**CITY OF CALLAWAY
BERTHE AVENUE BRIDGE REPLACEMENT &
ASSOCIATED INFRASTRUCTURE
BID NO.: PW2022-15**

ADDENDUM #3

Date Issued: October 10, 2022

GRADING PLAN

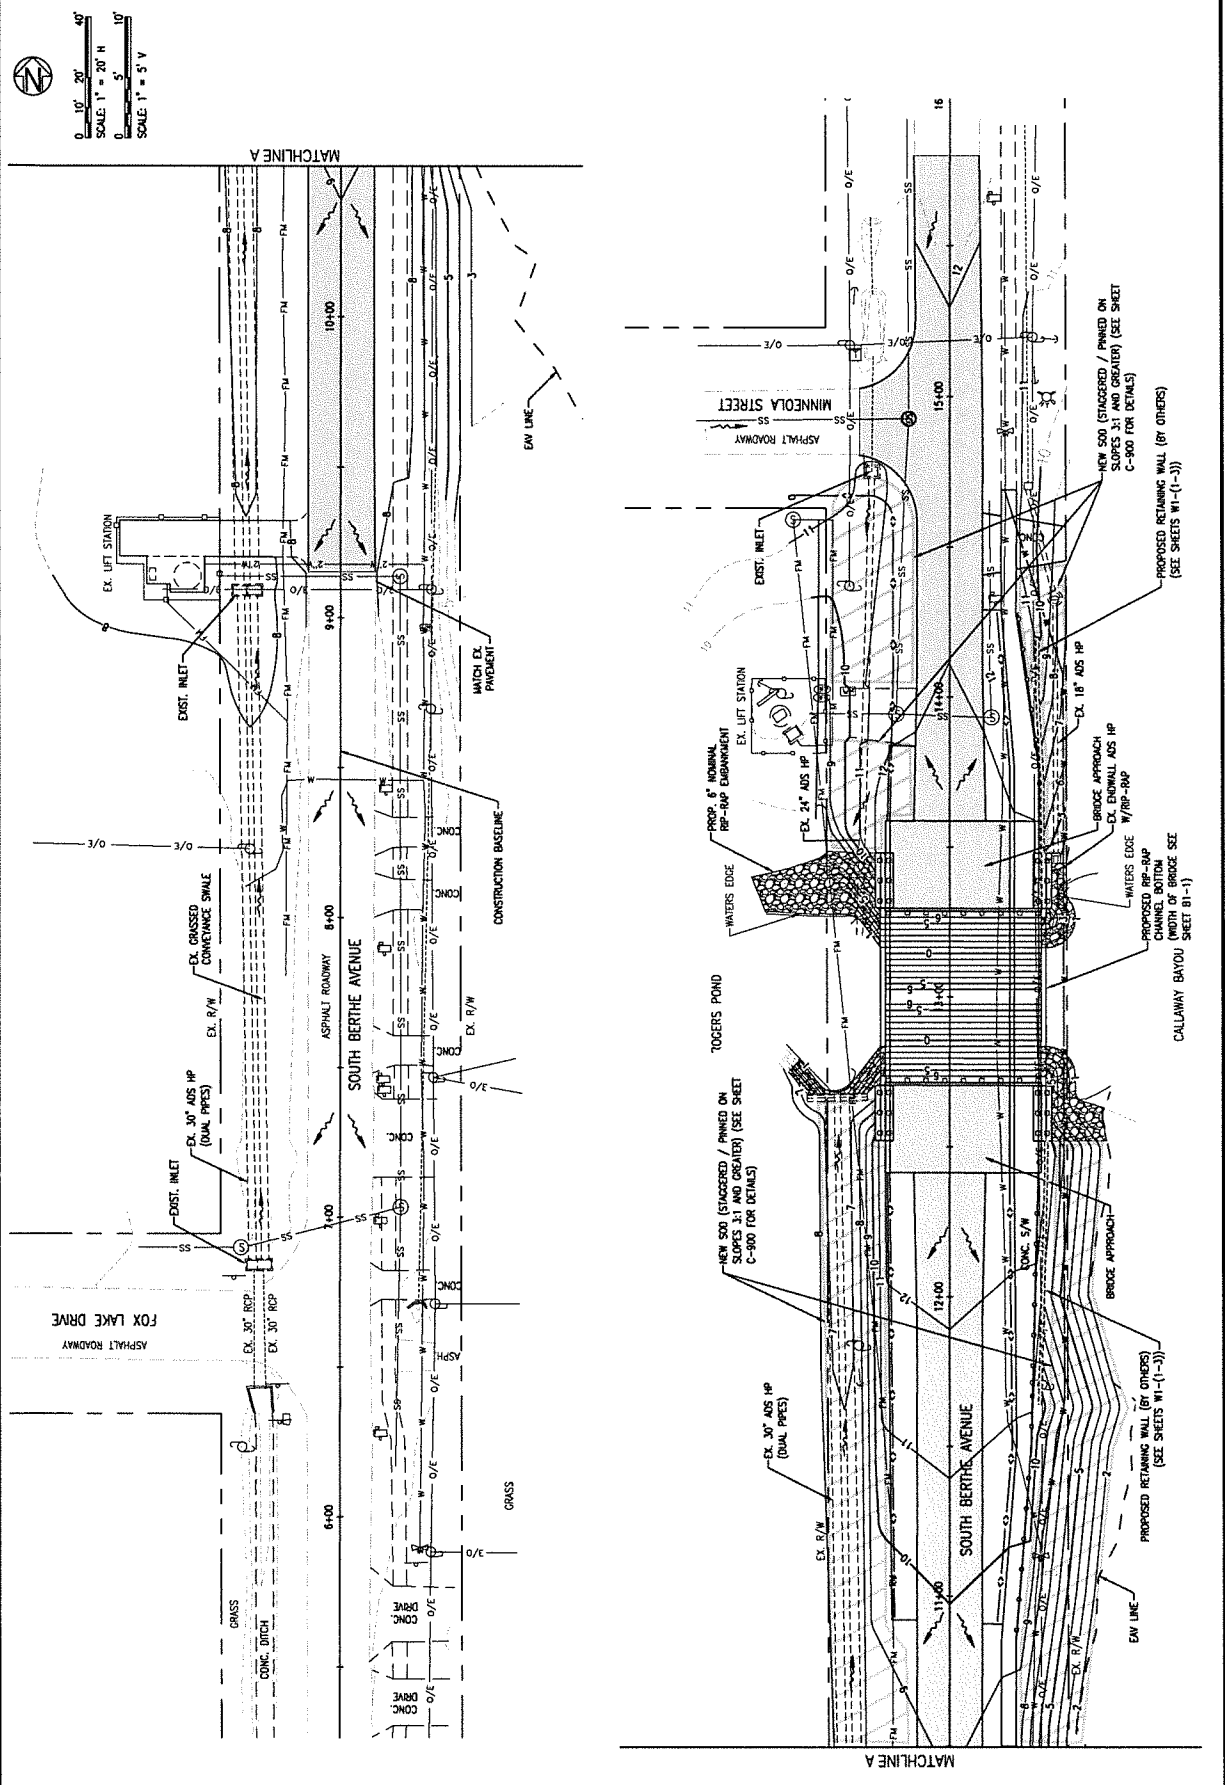
3. Reference sheet C-106. The note pertaining to the retaining wall states "proposed retaining wall (by others)? Please clarify.

- A. The note in question identifies that BDI was not responsible for design of the proposed retaining walls. BDI used Woolpert as the structural sub to perform bridge and retaining wall design and supporting calculations.
